**Before the
FEDERAL COMMUNICATIONS COMMISSION
Washington, D.C. 20554**

In the Matter of)	
)	
Viasat, Inc.)	IBFS File No. SES-LIC-20200811-00852
)	
Application for Blanket Earth Station License Using Ka-band Spectrum)	Call Sign E202143
)

**CONSOLIDATED OPPOSITION TO PETITION AND RESPONSE TO COMMENTS
OF VIASAT, INC.**

Figure 1: Plot of I/N as a Percent of Time for 75 cm earth station

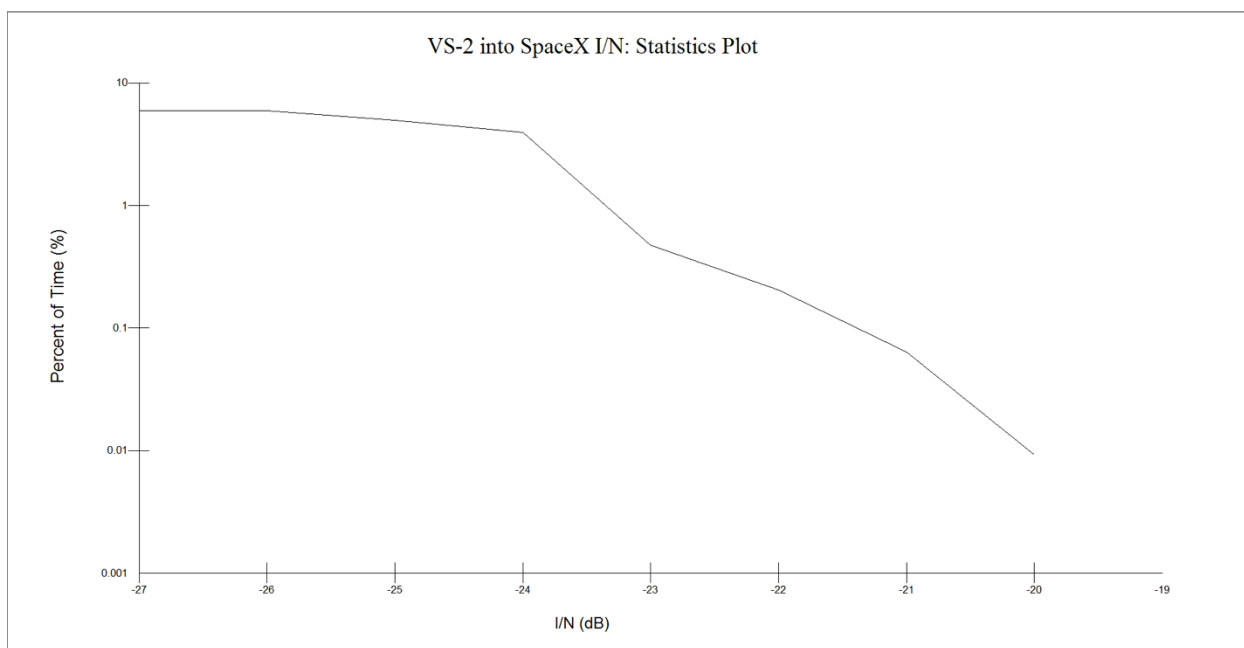
As noted in Viasat’s Petition, an analysis using the 22° isolation angle from GSO that SpaceX specifies in its application and letter produced a worst case I/N of about -19 dB, which equates to a $\Delta T/T$ of only 1.2% over a 24 hour orbital simulation run. The cumulative distribution function (CDF) plot of the run in Figure 1 below shows just how infrequently this occurs.

The plot shows that 99.99% of the time the I/N is less than -20 dB and less than a 1% $\Delta T/T$. Normally, between GSO networks, a coordination trigger of 6% $\Delta T/T$ is used. Due to the static nature of the alignments between earth stations and satellites in GSO networks, it is assumed that the 6% $\Delta T/T$ would be present 100% of the time. In the case of GSO vs NGSO networks, the alignments are not static, especially for LEO NGSOs having shorter duration

Figure 2: 30° Isolation I/N vs Percentage of Time for 75 cm earth station

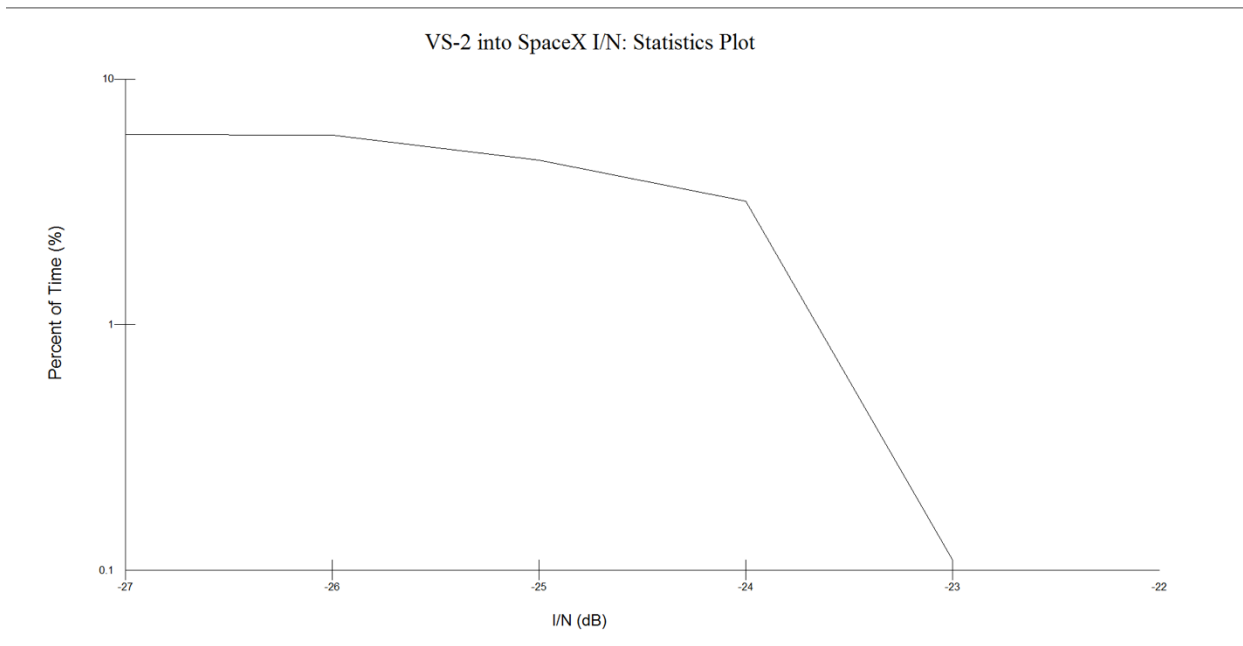
Because Viasat's simulation for the SpaceX network yielded a $\Delta T/T$ of less than 6% at the minimum 22° isolation angle more than 99.99% of the time, Viasat did not provide the results of the simulation for a 30° isolation angle, because a greater isolation angle would result in an even lower $\Delta T/T$ with an even greater percentage of time not exceeding 6% $\Delta T/T$ – in fact, 100% of the time an I/N of -22 dB was never exceeded – see Figure 2.

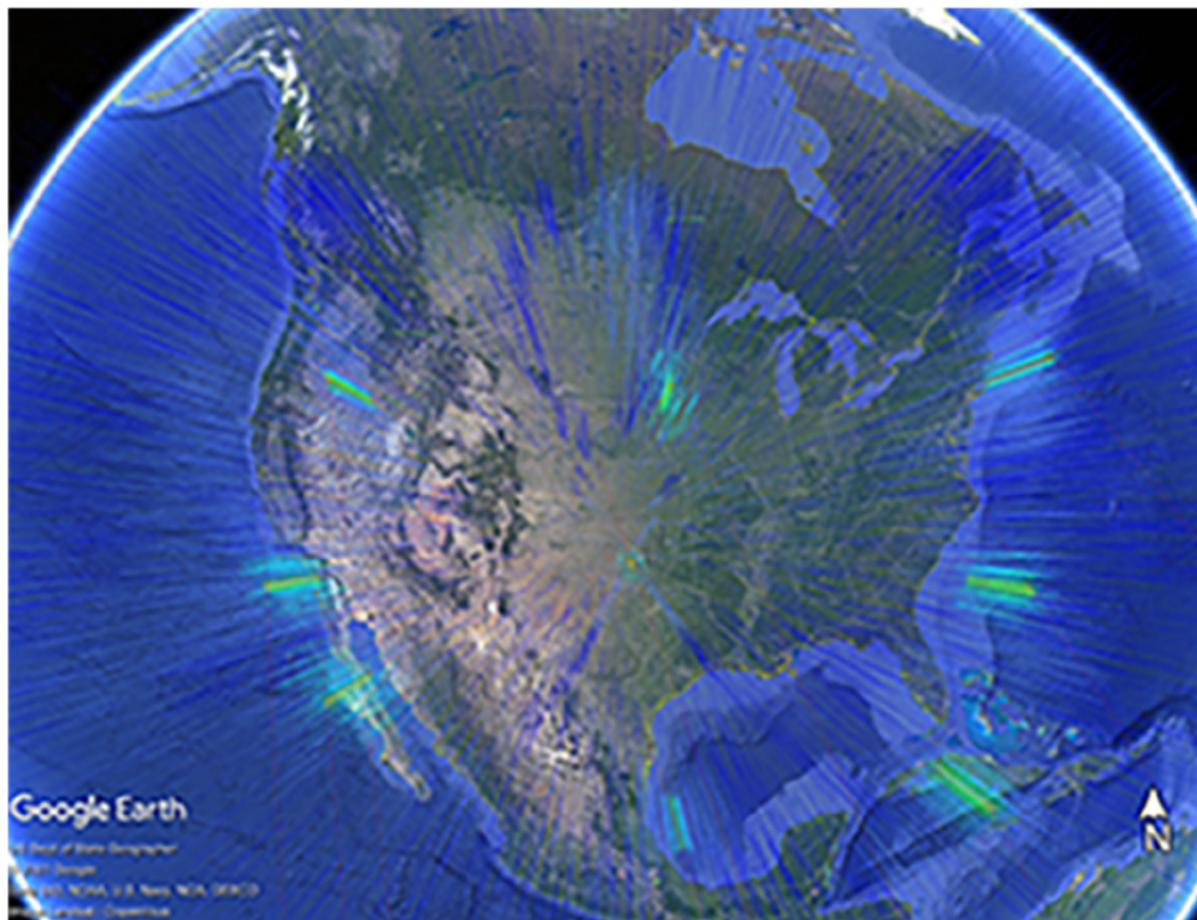
Viasat's Application provides detailed technical analysis demonstrating the absence of predicted harmful uplink interference from the operations under E170088 into various NGSO systems using the NGSO-primary spectrum.
